MESSAGE: Subject: The Toledo Edison Company, Distribution System, Eastern Area, Eastern
District Job 7749, Shield Building, Concrete Mix, Eastern Area, Eastern
Concrete Research Association, Eastern Area, Eastern District Job 7749

Re: Shield Building Wall
Toledo Edison Company
Oak Harbor, Ohio
Letter No. 21

PLANT Davis-Besse Nuclear Station

Exhibit 18: Wall Plumb Measurements

PLUMBNESS
 Exhibit 186

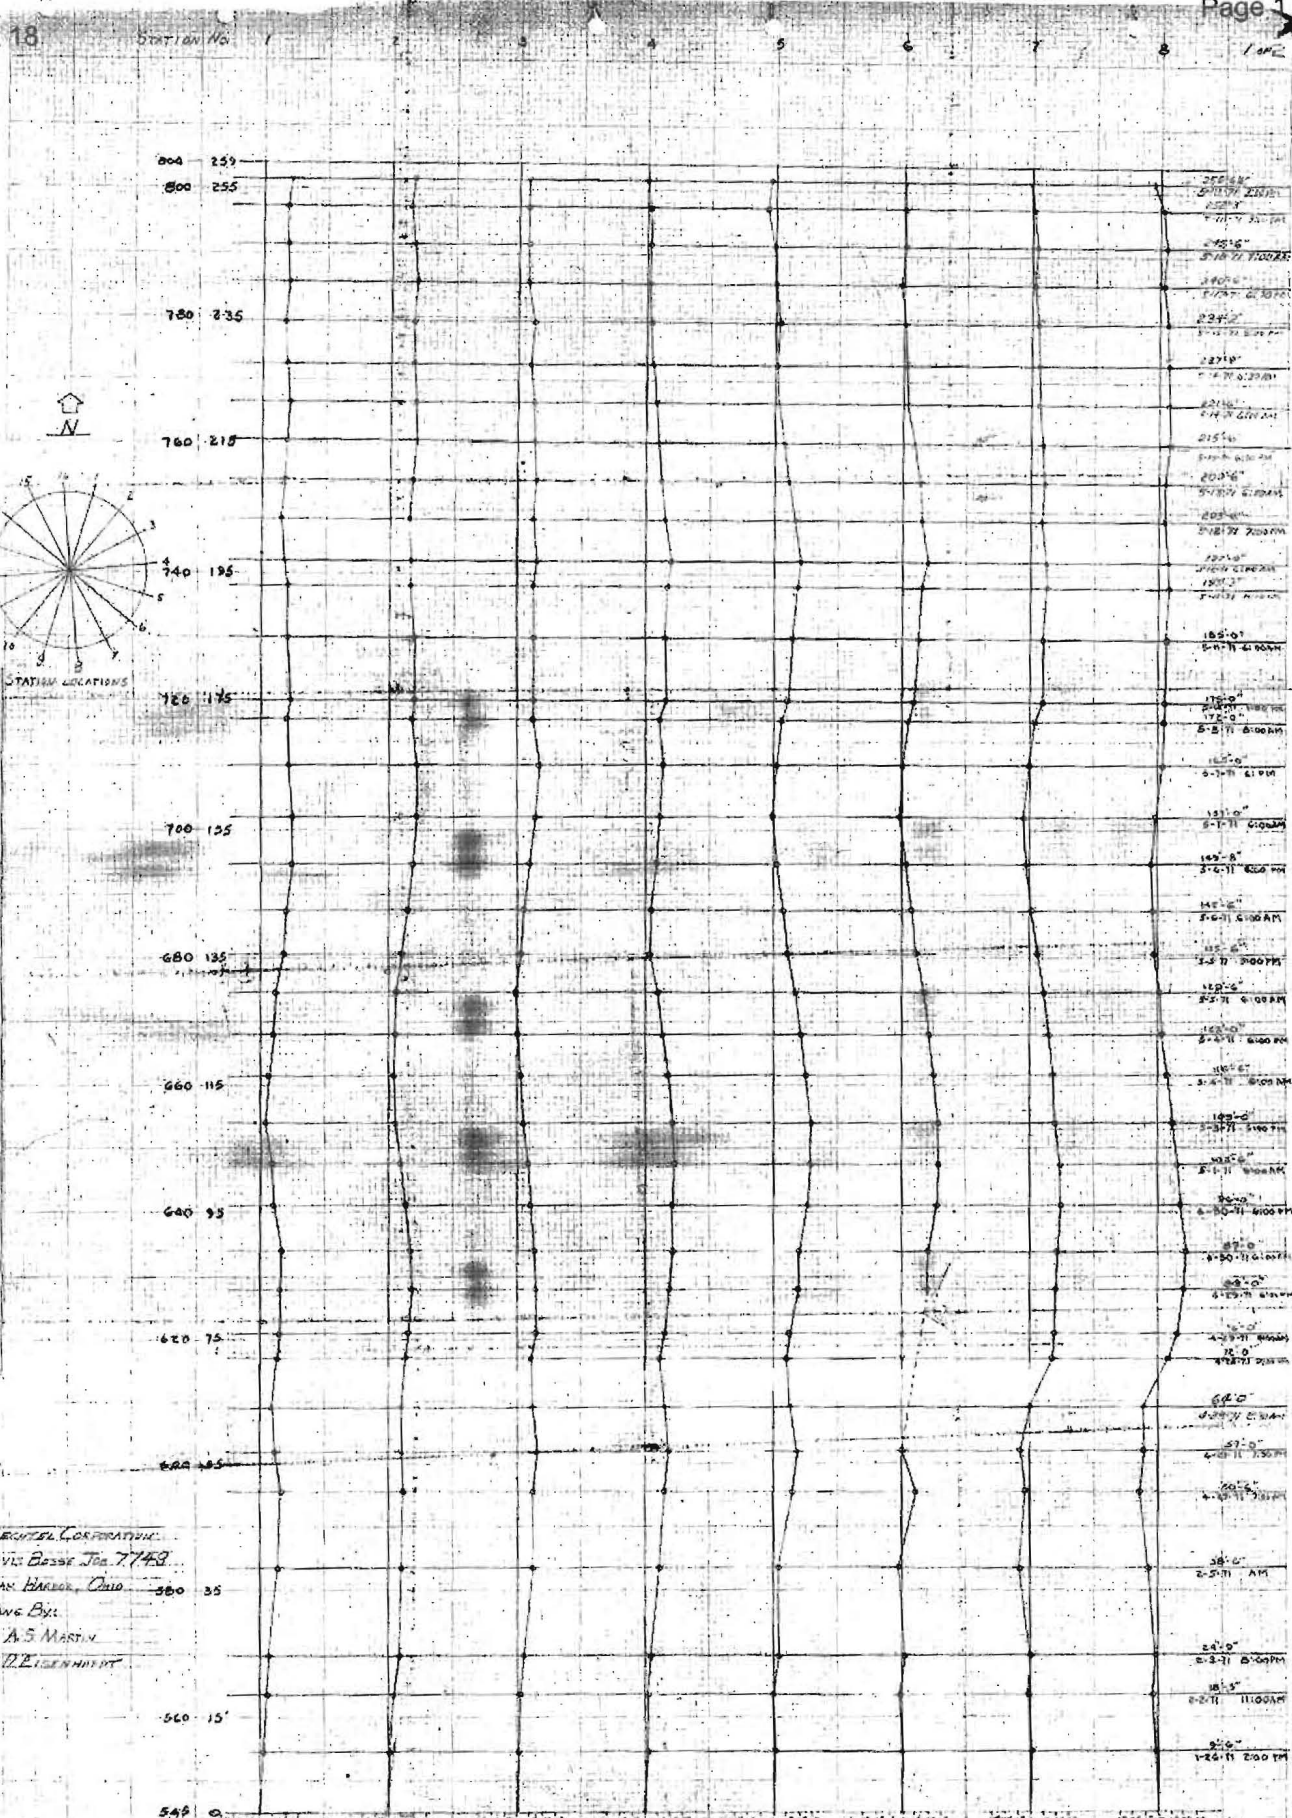
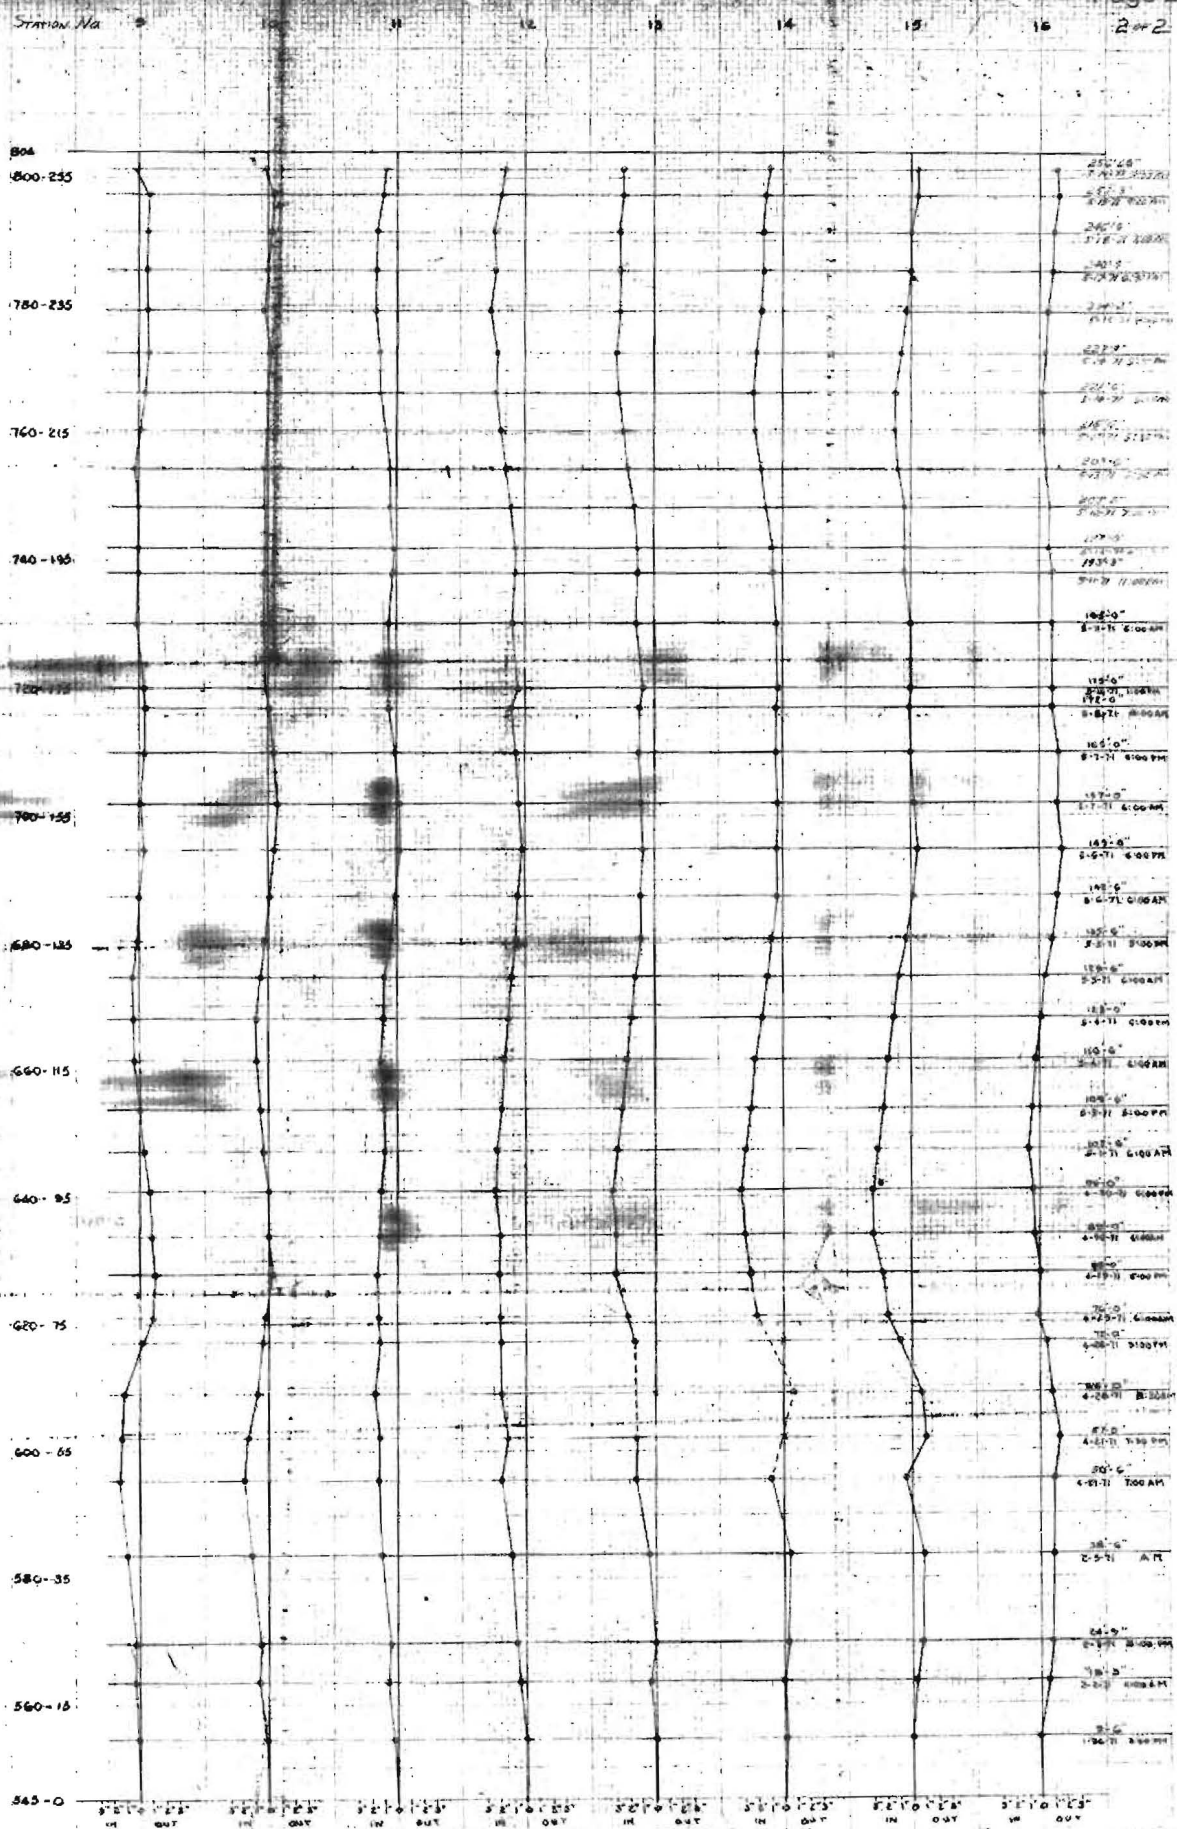
BECHTEL #5
 JOB NO. 7749 INTERIM FIELD REPORT SHEET 1 OF 1
 OWNER TECO-CEI PLANT Davis-Besse Nuclear Power Station UNIT 1
 STARTUP SYSTEM: NO. NA NAME Containment Shield Building
 QC NO. 1,2220 NON CONFORM. HOLD TAG NO. NA

SOLUTION OR SUGGESTED ACTION:
 Evaluate existing structure and approve as placed or provide recommended action.

BECHTEL
JOB NO. 7749 INTERIM FIELD REPORT REPLY SHEET 1 OF 1
REPORT NO. 5
OWNER TECO - CEI PLANT Davis-Besse Nuclear UNIT 1
Power Station
STARTUP SYSTEM: NO. N.A. NAME Containment Shield Building
QC NO. 1.2220 NONCONFORM, HOLD TAG NO. N.A.

FIELD CHANGE NOTICE REQUIRED	YES	NO <input checked="" type="checkbox"/>
FIELD CHANGE NOTICE ISSUED	NUMBER	N.A.
AS-BUILD DRAWING CHANGE REQUIRED	YES <input checked="" type="checkbox"/>	NO
